| <b>Metro Manila Subway Project Phase 1<br/>Package CP106: E&amp;M Systems and Track Works</b> |  |   |  |
| <i>Volume II, Part 2 – Employer’s Requirements<br/>General Requirements</i>                   |  |   |  |

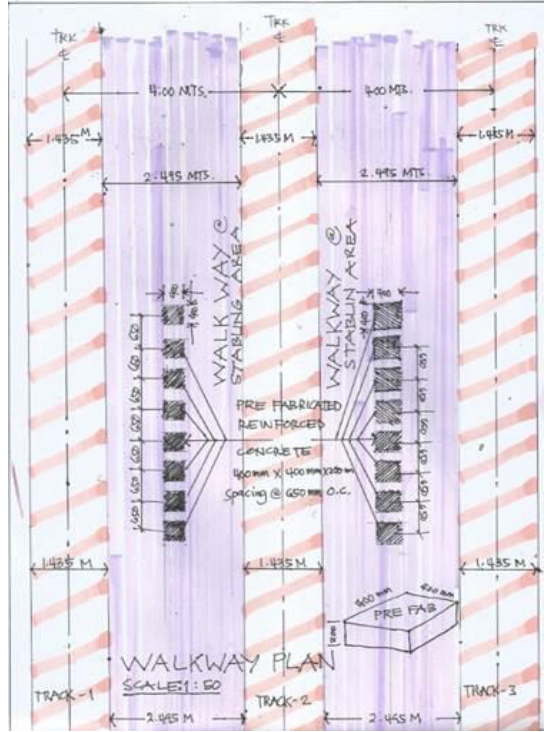
| <b>Metro Manila Subway Project Phase 1<br/>Package CP106: E&amp;M Systems and Track Works</b> |   |   |  |
|---|---|---|--|
| 4.  | 01 Track works _12 Dec 2019 (PA)<br>Clause 1.20 | Please provide the layout position of the walkway | Staff walkway layout in the depot shall be position on areas along center line between ballasted tracks but not limited to Stabling area, PRI and TC area, OCS and PWay maintenance area. Refer to the sketch below;   |
